# Environmental Minor Project Refinement Form

Project Name: West of Devers Upgrade Project (WOD) Request Prepared By: Sylvia Granados

Date Approval Required: 8/10/2018 Variance Request No.: 18

*Southern California Edison*  
 West of Devers Upgrade Project  
**STWA-1-SRedlandsAve**  
 Expanded Work Area  
 MPR #18

FIGURE 1

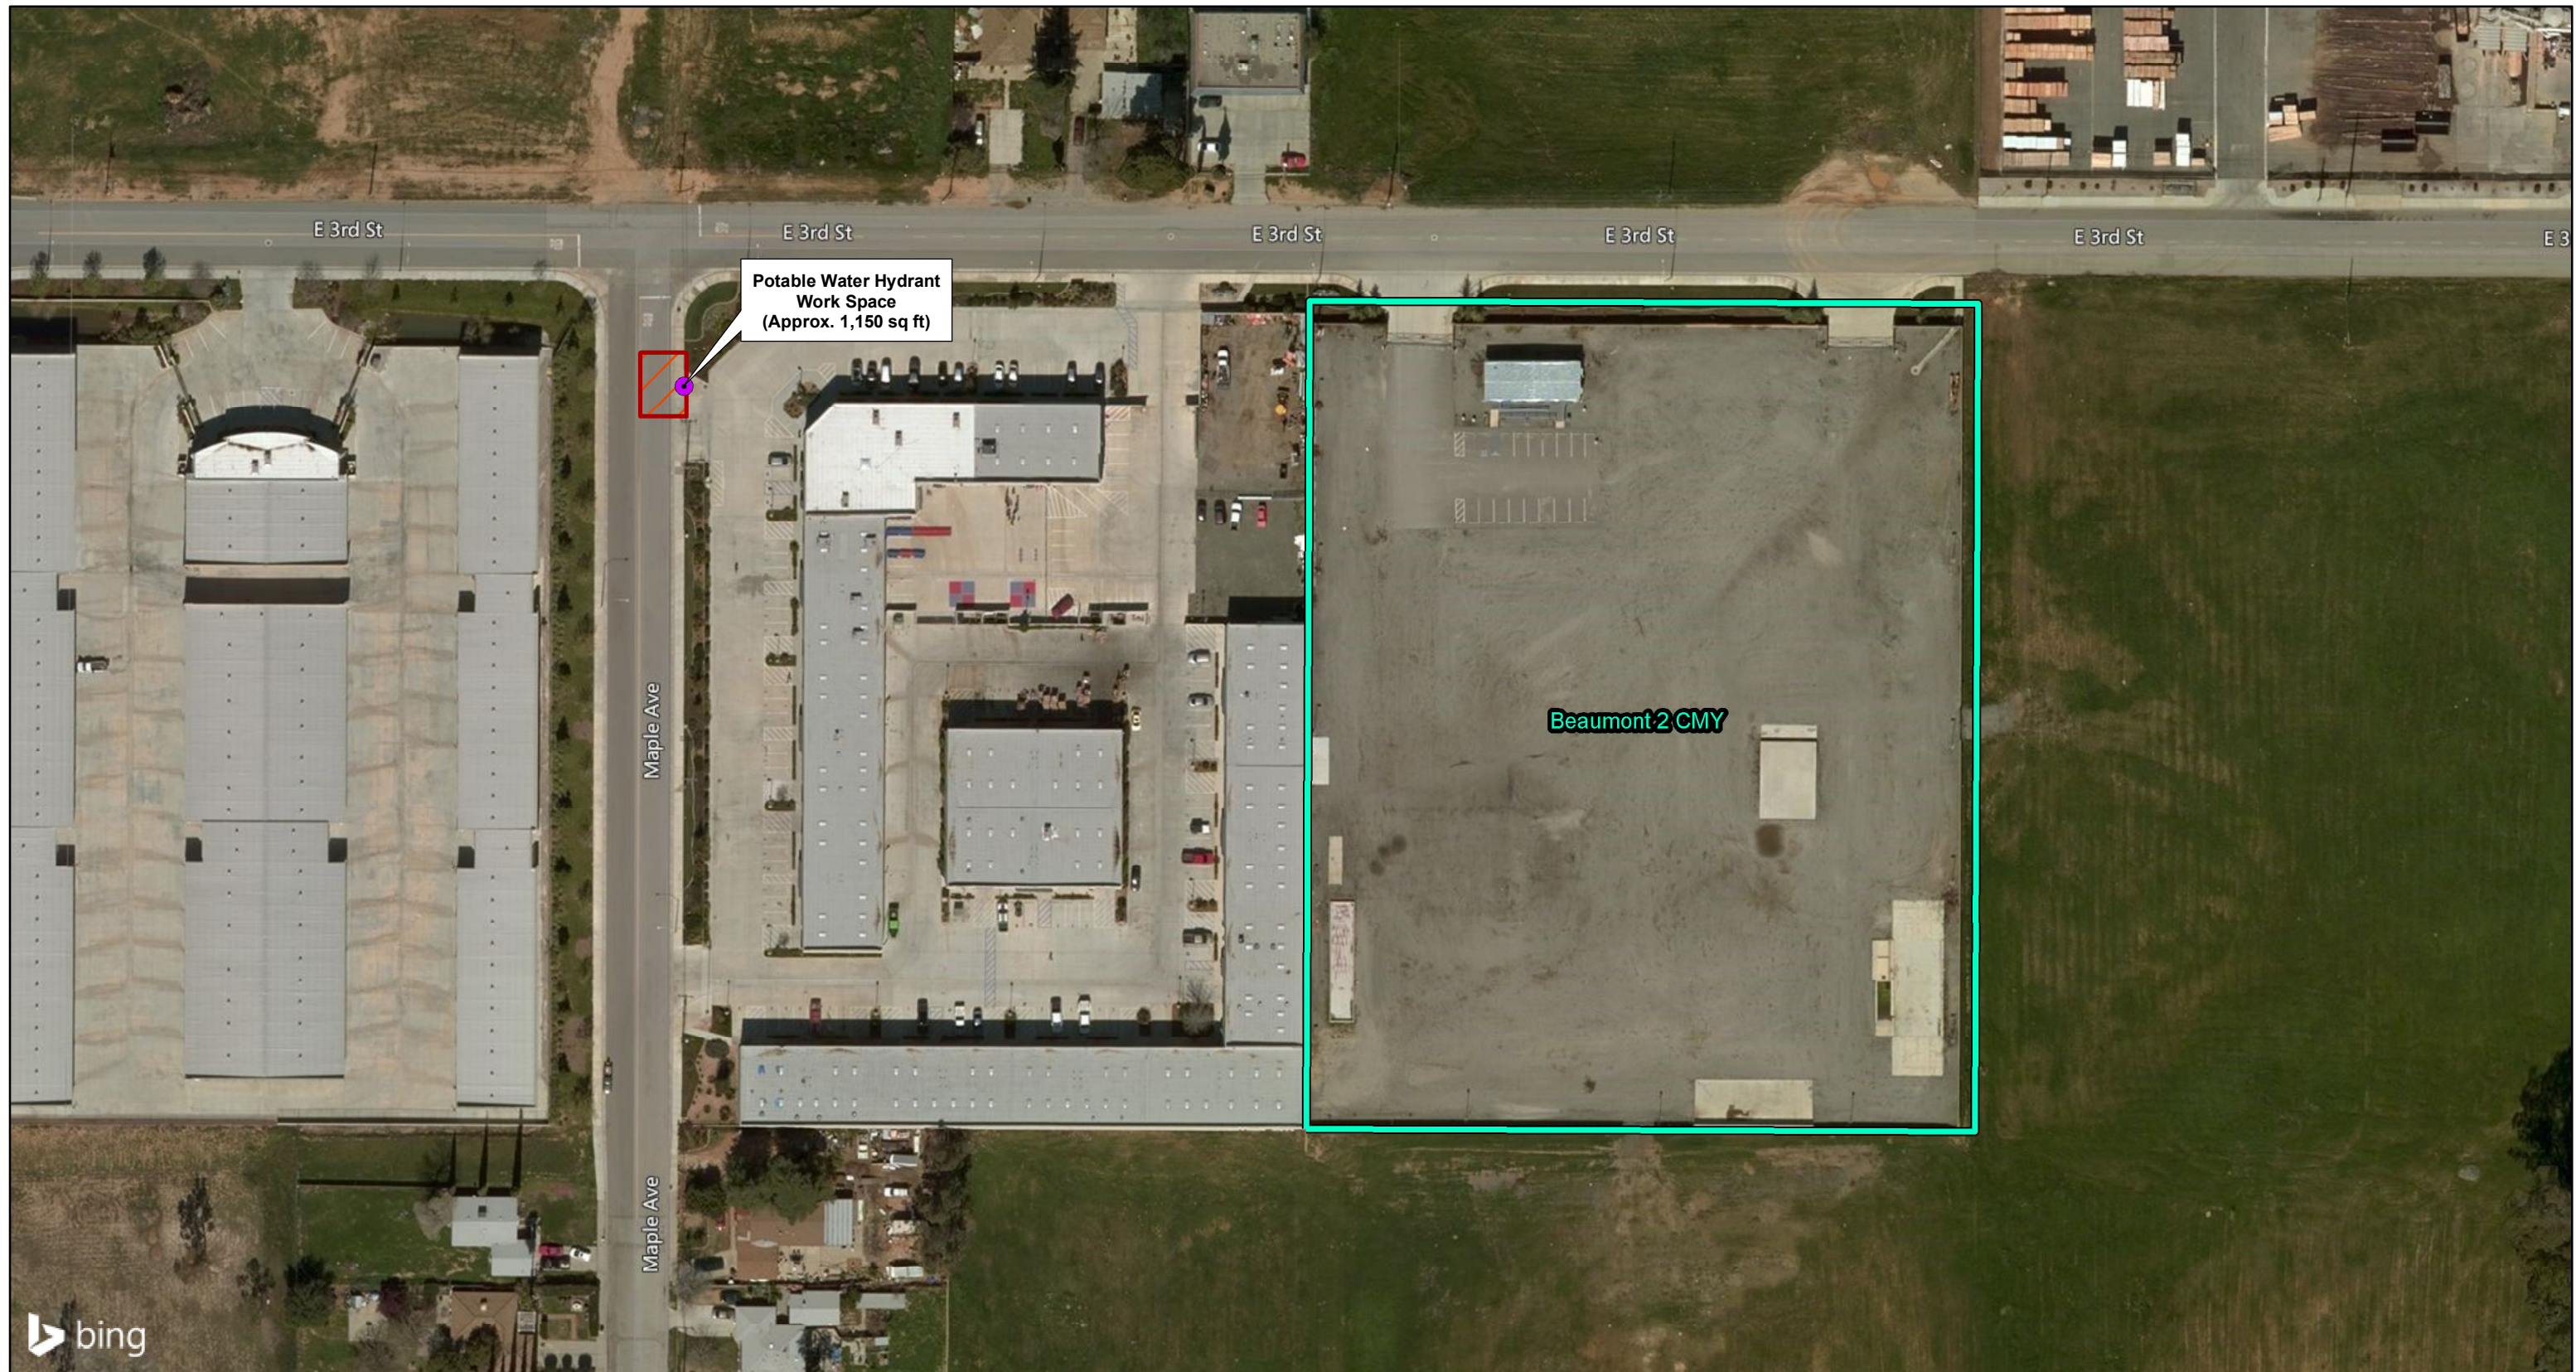
### **Segment 1 - Subtransmission Vault 6001323**

The work area for Subtransmission Vault 6001323 has been expanded to facilitate installation of the vault. The removal of four (4) cypress trees and a block wall is required in the new work area to provide additional work space for material and equipment staging and access during the underground vault installation, as shown in Figure 1.

The temporary impacts associated with the new work area total 0.07 acres, on developed, light industrial, private property with ornamental land cover and finished surfaces.

FIGURE 2

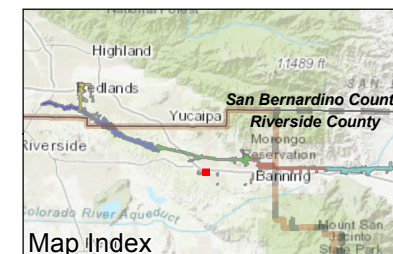
### **WOD Water Source**

The potable water source located at the corner of Maple Avenue and 3<sup>rd</sup> Street in Beaumont is required to support WOD transmission line activities associated with the Beaumont #2 Material Yard, located within 450-feet of the new water source, as shown in Figure 2.

Water trucks will park adjacent to the existing water source location shown in Figure 2, on the paved road. Only occasional short-term filling of water trucks will occur, while allowing access to local Industrial land uses. No ground disturbance will occur at the water source location. Use of the nearby hydrant will reduce vehicle emissions and traffic impacts to local/regional roadways.
